ADMINISTRATIVE MEMORANDUM NO. 21-043

SUBJECT: Bid Review, 7th Avenue Properties LLC, IFB 21-01, 1207 East Atlantic Blvd

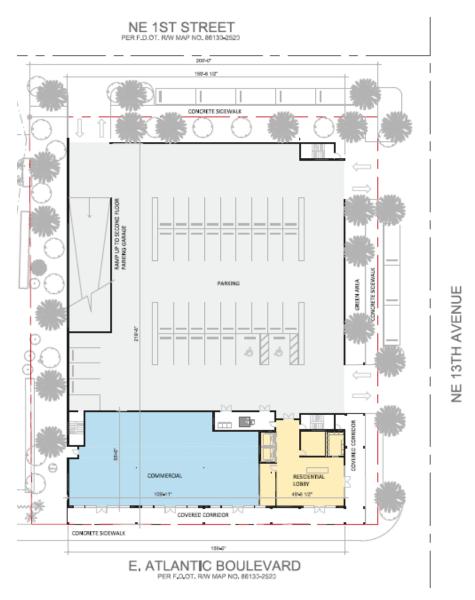
Along a primary and secondary street, the ground floor of the garage shall be screened by a liner building containing a minimum depth of 20 feet that may be used to achieve the minimum active use requirement in the Overlay District, pursuant to Section 155.3501.I.2.c.i. Above the ground floor, a liner building shall not be required. NE 1 St is ranked as a secondary street on the Street Network Connectivity Regulating Diagram. The conceptual ground floor plan depicts the parking garage abutting the exterior wall on NE 1 St, without the required liner building, and thus the plan does not comply.
